**TABLE 2-4
LOCAL AGENCIES SUBMITTING COMMENTS**

Subject: Draft Environmental Impact Report for the Cadiz Valley
Water Conservation Recovery, and Storage Project

THE METROPOLITAN WATER DISTRICT
OF SOUTHERN CALIFORNIA

FIGURE 1

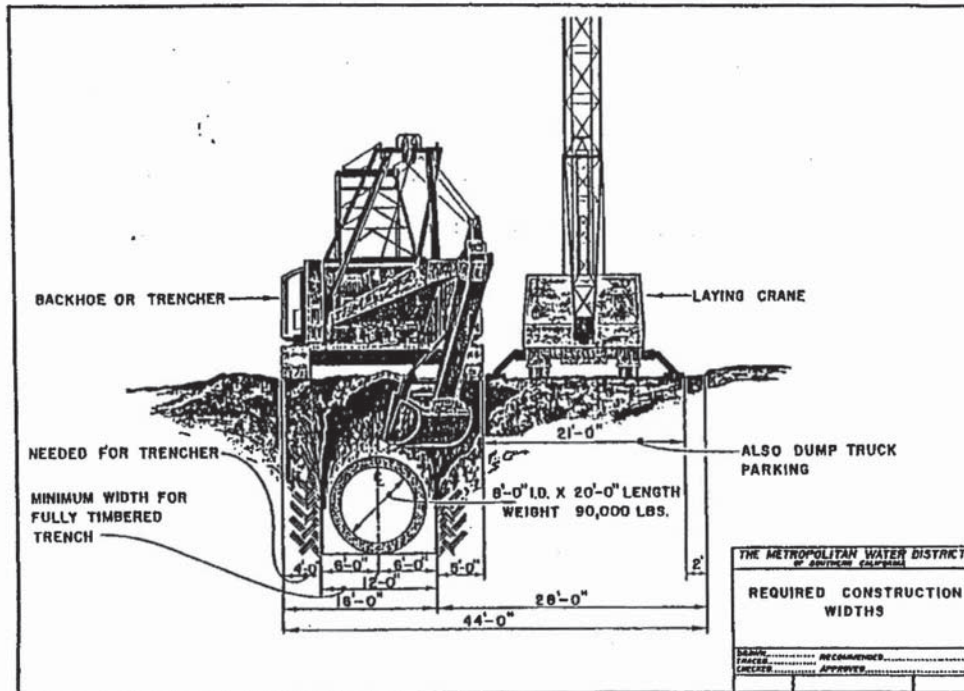
d. Deep-rooted trees are prohibited within Metropolitan's fee properties and/or easements. Shallow-rooted trees are the only trees allowed. The shallow-rooted trees will not be permitted any closer than 15 feet from the centerline of the pipeline, and such trees shall not be taller than 25 feet with a root spread no greater than 20 feet in diameter at maturity. Shrubs, bushes, vines, and ground cover are permitted, but larger shrubs and bushes should not be planted directly over our pipeline. Turf is acceptable. We require submittal of landscape plans for Metropolitan's prior review and written approval. (See Figure 3).
